REVISED

RE: Upcoming presentation to the Historical Commission on February 13, 2025

25 S VAN PELT ST
PHILADELPHIA, PA 19103

SOUTH ELEVATION
(EXISTING & PROPOSED)
REVISED 02.05.2026

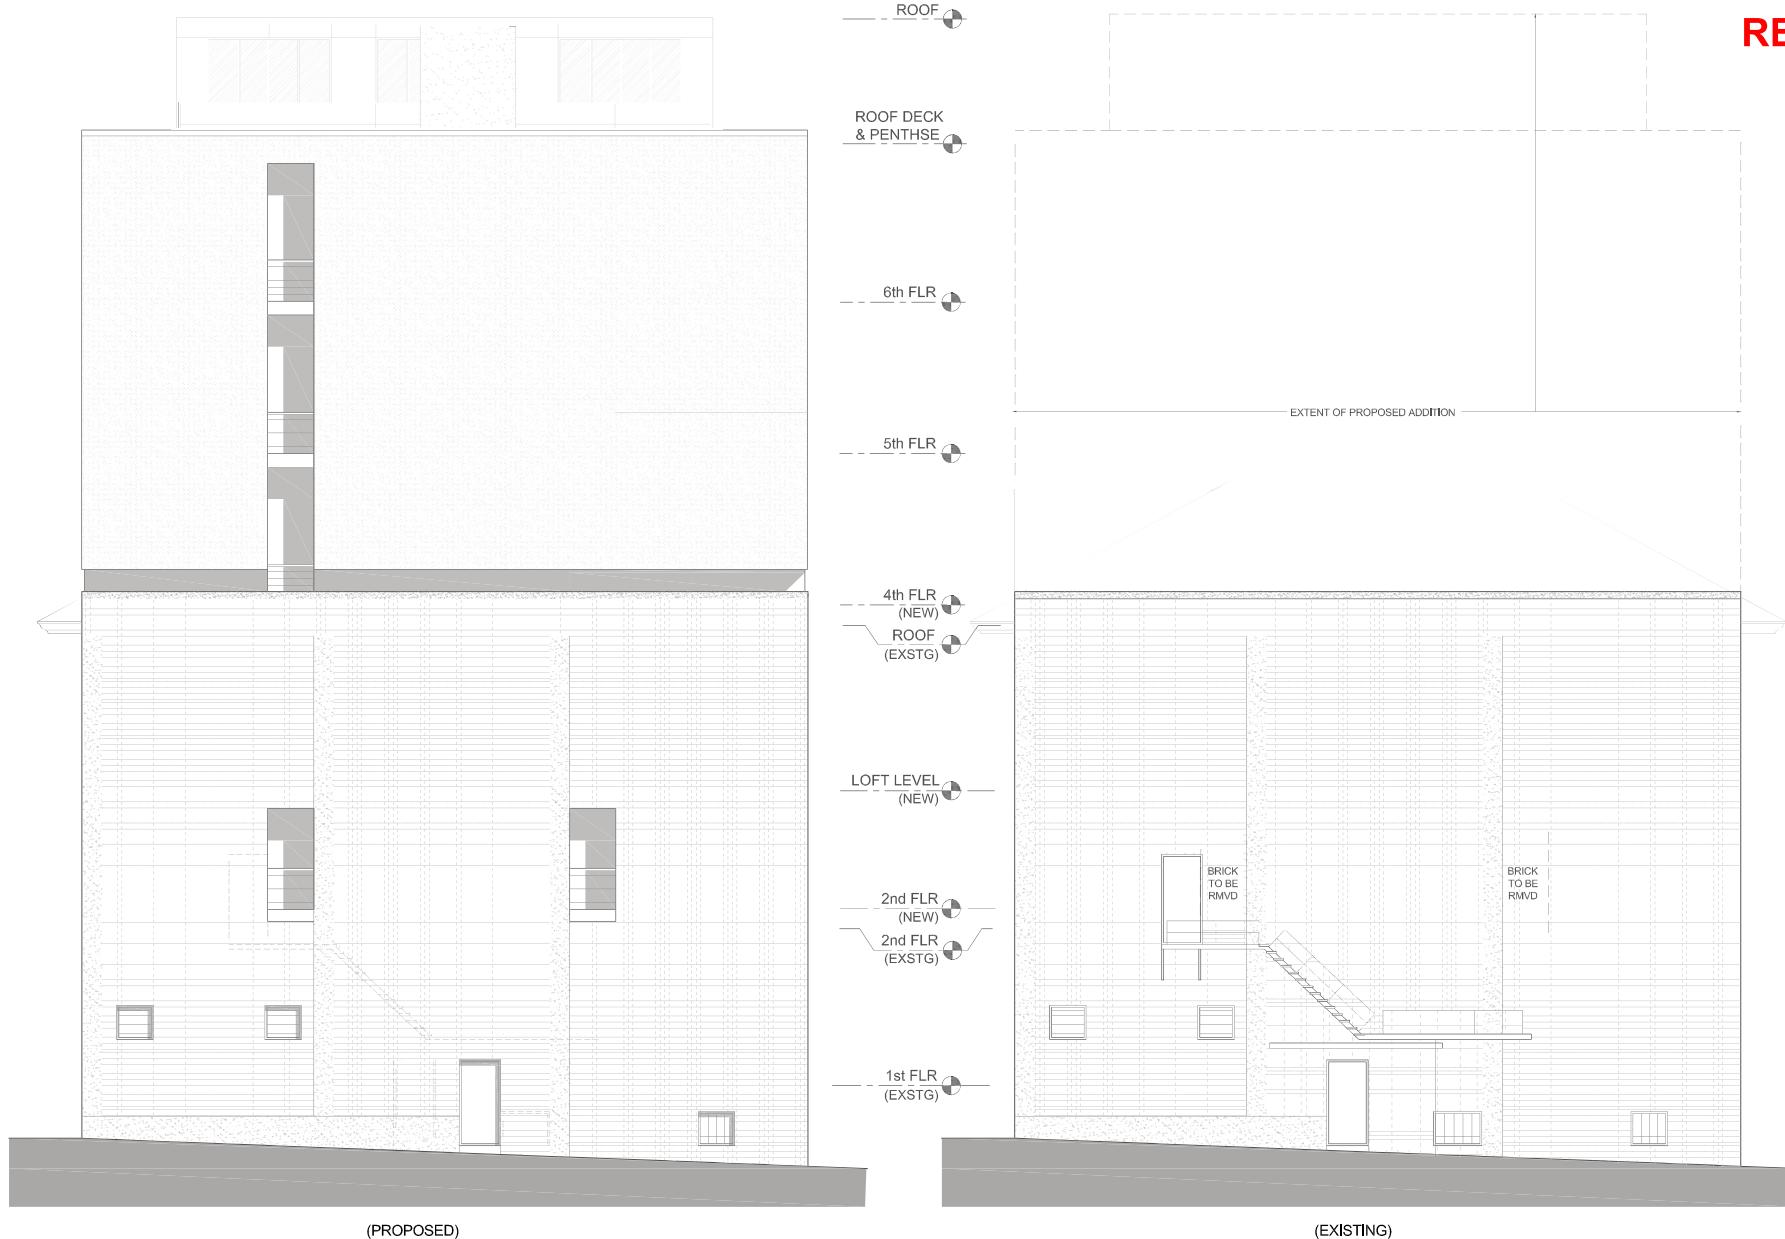
Lastly, the latest redesign included relocating one of the egress stairs to the north end of the property. In doing this, it freed up space along the south facade (in the 4th, 5th, & 6th Floor units) and allowed us to wrap the curtain wall system on the west facade around the corner. We feel this further adds to "lightness" of the addition, especially as it fronts the hip roof of the 1894 building. As well, we added a solid portion of metal paneling the north end of the west facade that directly aligns with the 3-story solid brick portion below, ultimately highlighting the asymmetry that occurs at the gymnasium clerestory.

FIRST FLOOR PLAN

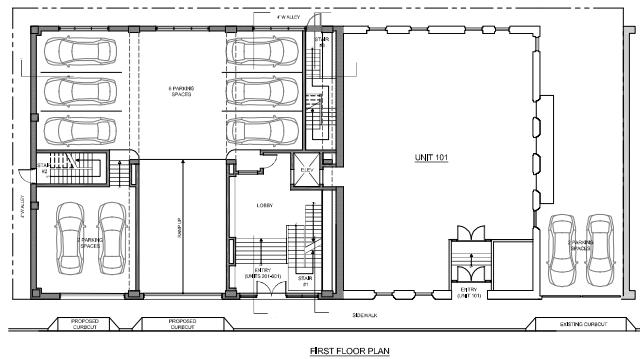
Additionally, per an Arch Comm recommendation, we added a storefront system to enclose the main pedestrian residential entry - with the proportion and mullion spacing also closely following the existing window system.

SECOND FLOOR PLAN

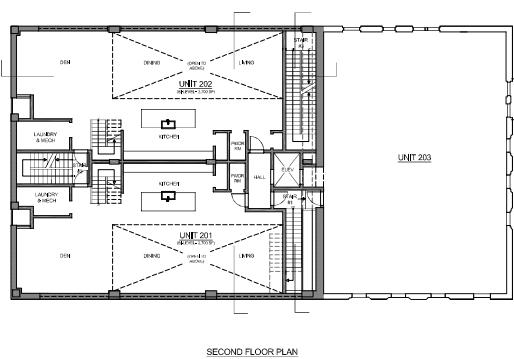
As shown in the supplemental Plans & Sections that we've submitted, by raising the elevation of the 2nd Floor level and placing the loft levels in the 'core' of the space, we eliminated the need for any new openings at the 2nd Floor level along the West & East facades. As well, the replacement window system that will be installed within the existing clerestory opening will very closely follow the proportion, mullion spacing, and operation (awnings) of the existing system.

LOFT LEVEL PLAN
(@ THIRD FLOOR)

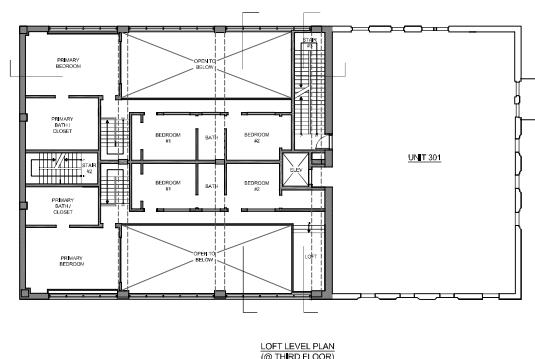
The following addresses the overview/staff recommendations provided by Historical Commission based on our January 27, 2025 presentation to the Architectural Committee. Our team decided to take a closer look at the proposed design based on the comments. In particular, we took another pass at the 2nd & 3rd Floor levels in the Gymnasium building and concluded that the best way to best preserve the integrity of the existing facade (mainly in regarding the clerestory window) was create two, back-to-back, 'bi-level' units at the 2nd Floor (as opposed to a 'flat' at the 2nd Floor and a 'flat' at the 3rd Floor, which was previously proposed).
